285 EAST 10<sup>TH</sup> AVENUE (COMPLETE APPLICATION)  
DE416894 - Pending ZONE CD-1

**EXECUTIVE SUMMARY**

**DEVELOPMENT PERMIT STAFF COMMITTEE RECOMMENDATION: APPROVE**

**Roof Plans**  
 A1.15

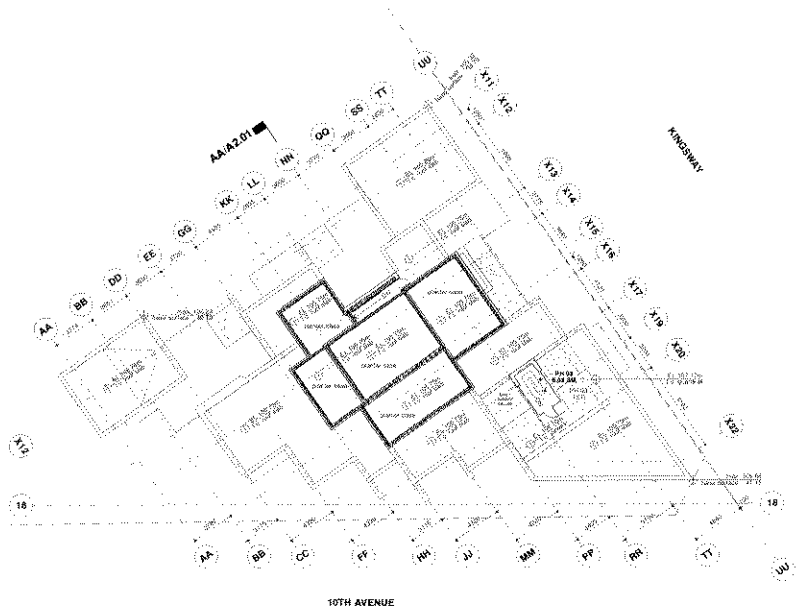
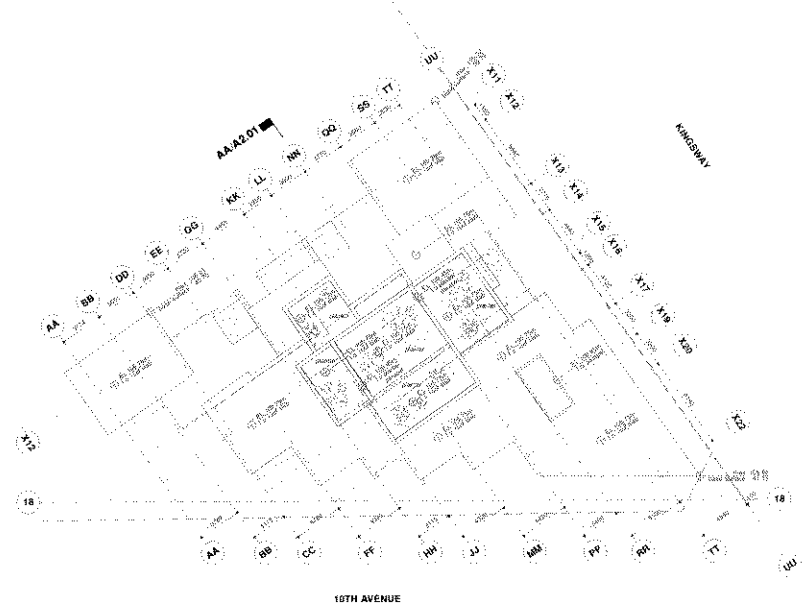
- ii. detailed roof elevations for each roof level in the building, including top of all rooftop elements, such as parapets, guardrails, and planters, should be shown on the roof plan and match levels shown on the elevation and section drawings;

Section AA  
 Drawing number  
**A2.01**

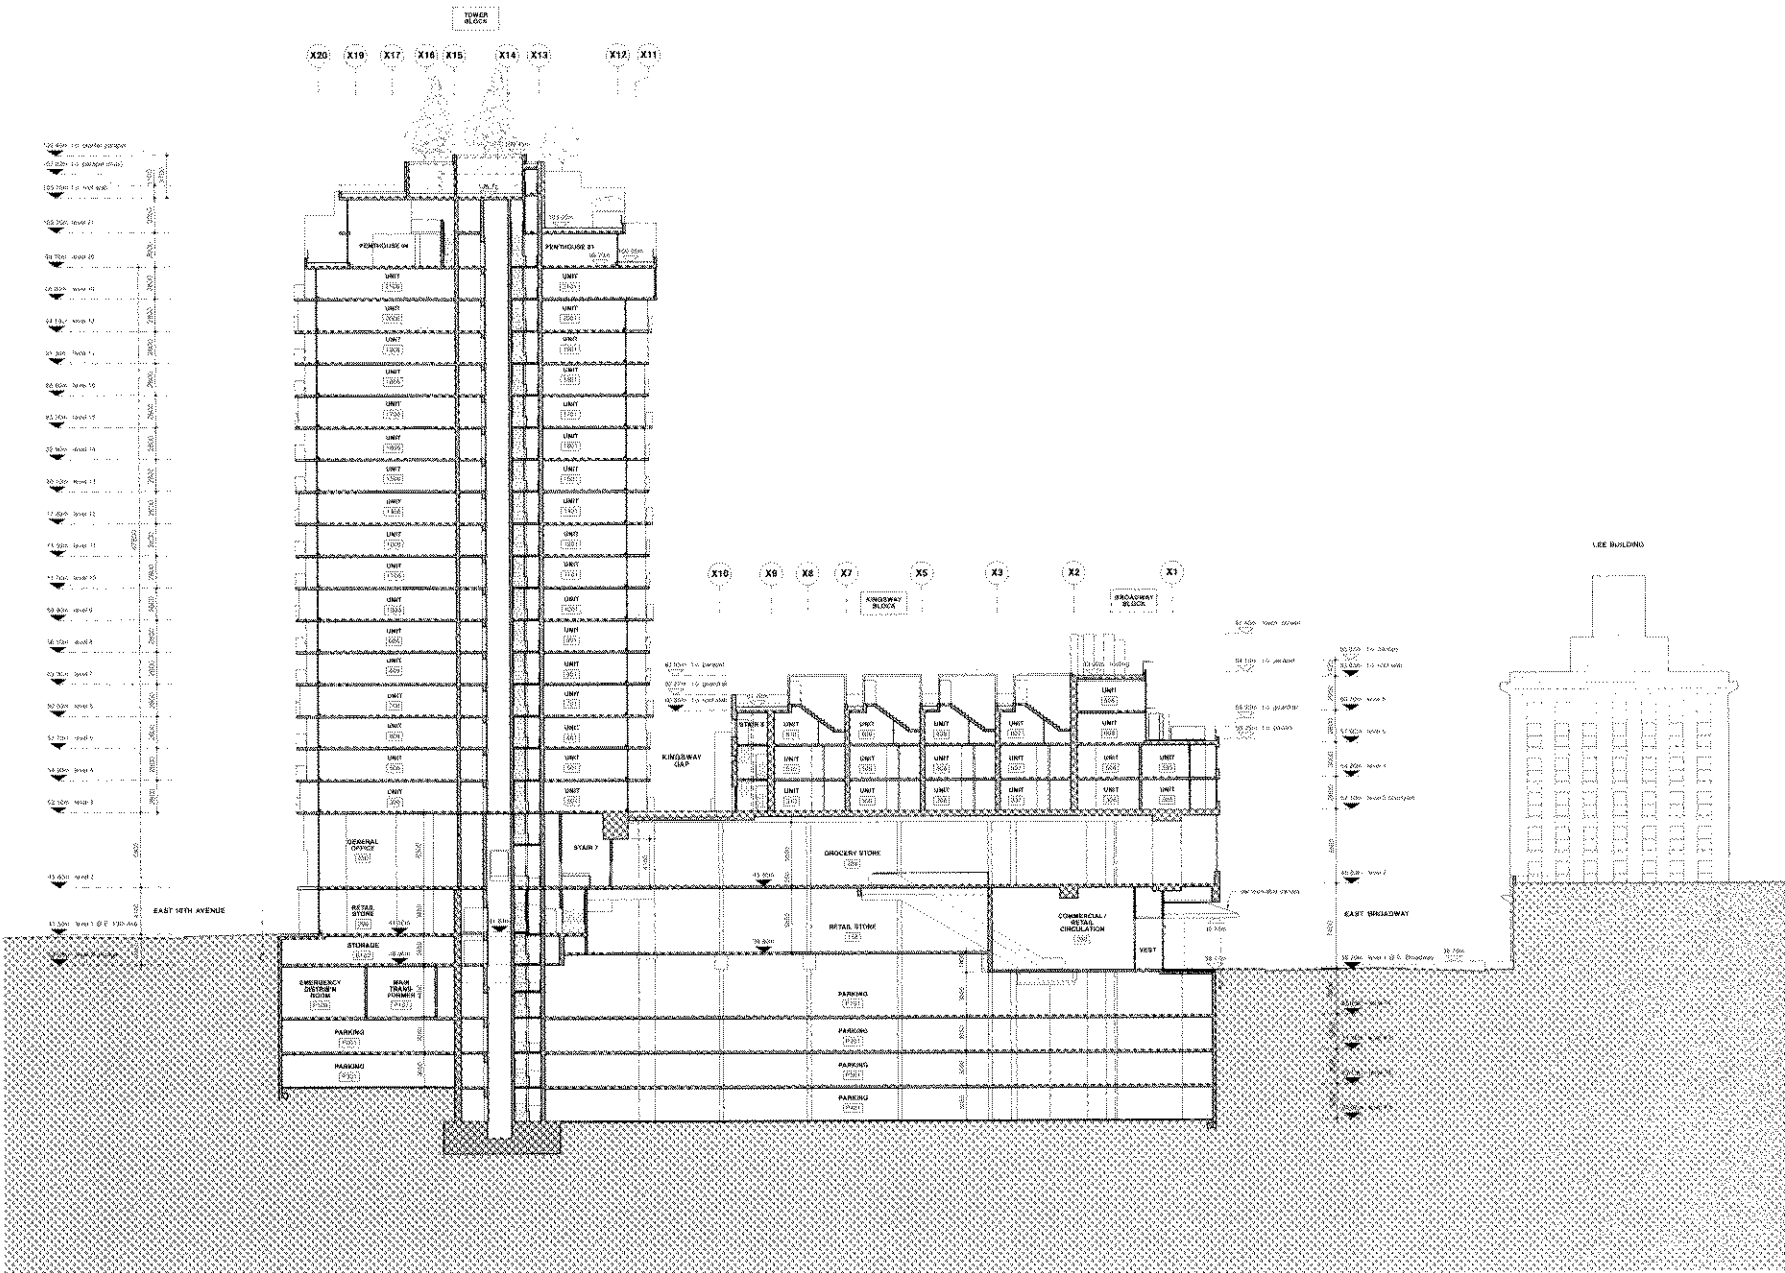
- A.1.18 coordination of architectural and landscape plans to clarify tower tree planter depth on A2.01 and the landscape plans;

**L 1.05**

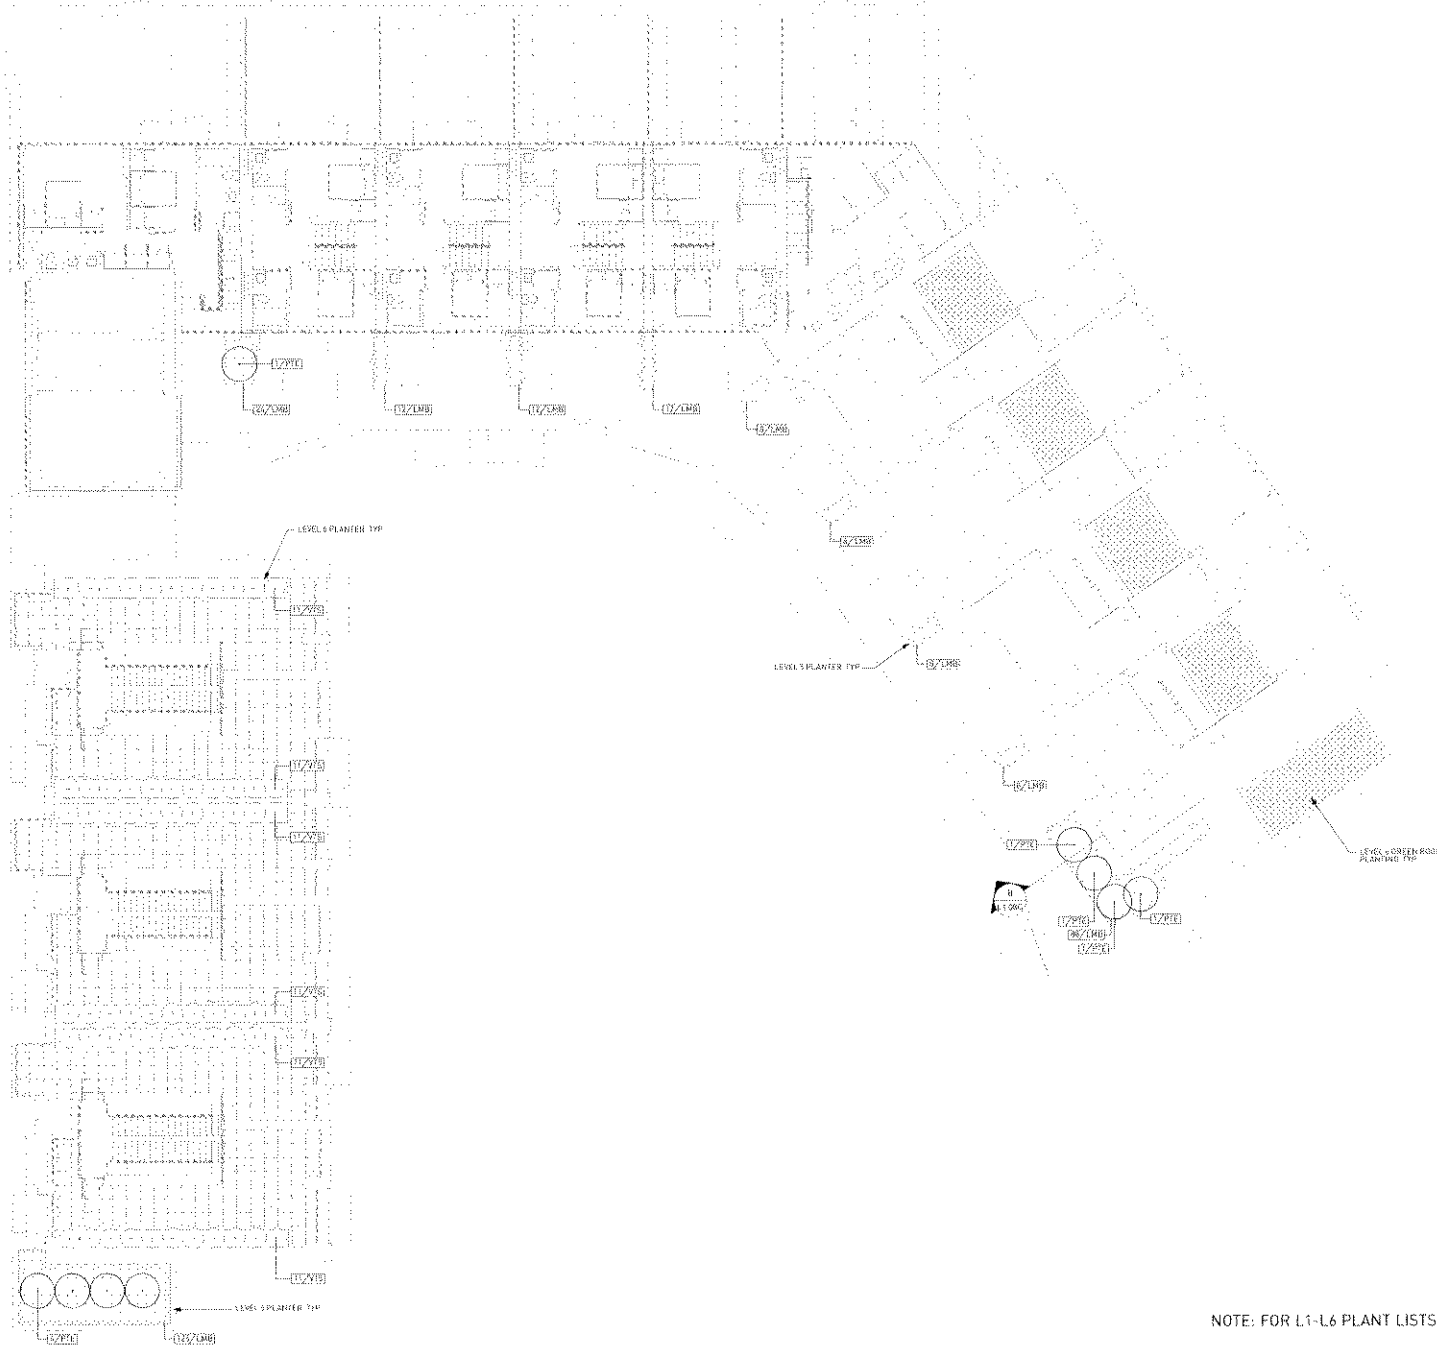
- i. information on the Architectural and Landscape Plans does not match; and
- ii. six Class B bicycle spaces proposed on City property along Watson Street, shown on Drawing No. L 1.05 of the Landscape Plans, require the approval of the General Manager of Engineering Services;
